**UNITED STATES
DEPARTMENT OF THE INTERIOR
BUREAU OF LAND MANAGEMENT**
Sundry Notices and Reports on Wells

PLUG AND ABANDONMENT PROCEDURE

E Ton na Gash 8 #43

Re: Permanent Abandonment
Well: E Ton na Gas 8 #43

E Ton na Gash 8 #43**Proposed P&A**

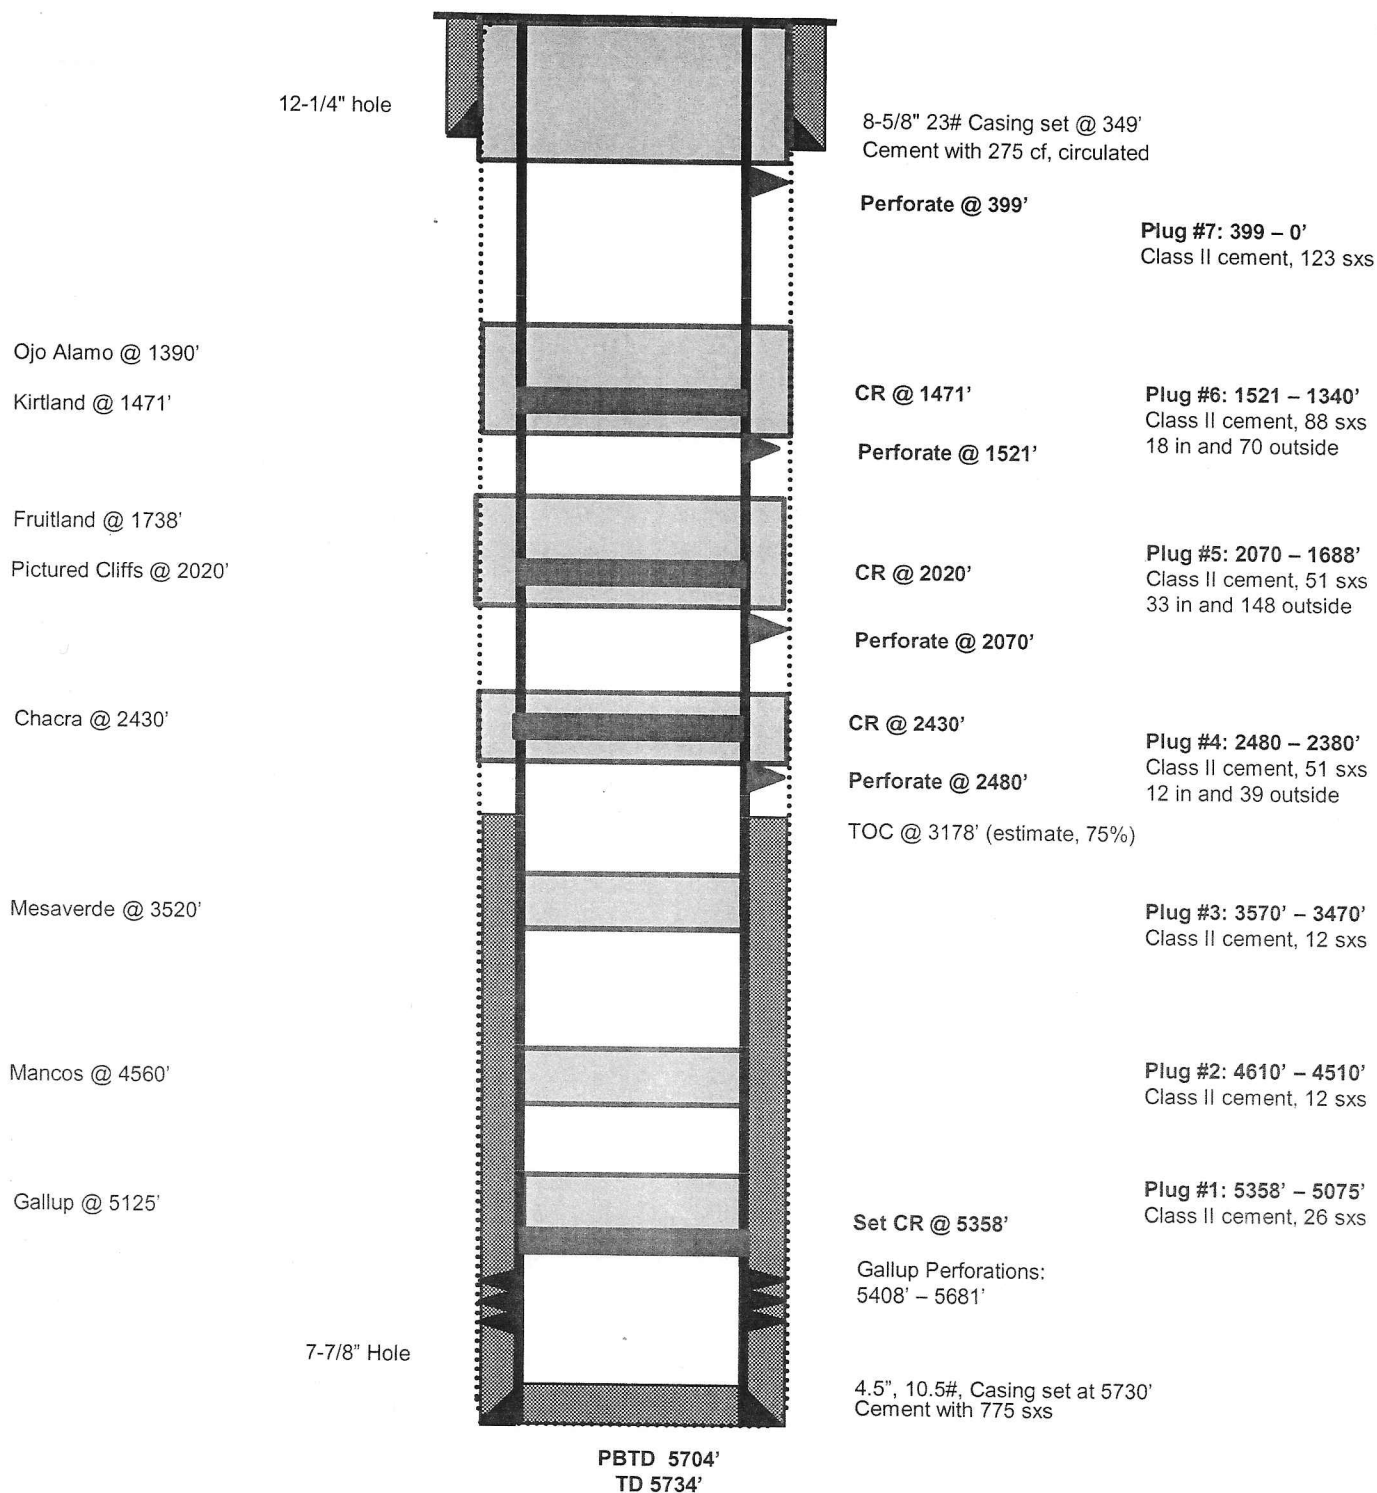
3. The following modifications to your plugging program are to be made:
 - a) Confirm cement volumes for each plug with BLM Field Inspector before starting work. The volume in the procedure does not matches up with the volumes in the proposed wellbore schematic.

- b) Adjust plug # 4, or include an additional inside/ outside plug, to cover the interval of 2970-2870 ft. This is to isolate the top of the Chacra.
 - c) Adjust plug # 5 to cover the interval of 2080-1688 ft. This is to isolate the top of the Pictured Cliffs and Fruitland.

- d) Adjust plug #6 to cover the interval of 1555-1340 ft. This is to isolate the top of the Kirtland and the Ojo Alamo.

- BLM pick for the Kirtland, Fruitland, Pictured Cliffs and Chacra formation top varies from operator pick.
- Plug #4 (Chacra) should be adjusted, or an additional inside/outside plug should be added, to cover interval from **2970'-2870'** as BLM Chacra formation top pick is at 2920'. Operator picked Chacra top at 2430'. Adjust cement volume accordingly.

- Plug #5 (Pictured Cliffs and Fruitland) should be adjusted to cover interval from **2080'-1688'**. Adjustment will cover both BLM and Operator Pictured Cliffs and Fruitland formation top picks. Adjust cement volumes accordingly.

- Plug #6 (Kirtland and Ojo Alamo) should be adjusted to cover interval from **1555'-1340'**. Adjustment will cover BLM Kirtland formation top pick at 1505'. Top of plug can be left at 1390' to cover the Ojo Alamo top. Adjust cement volumes accordingly.
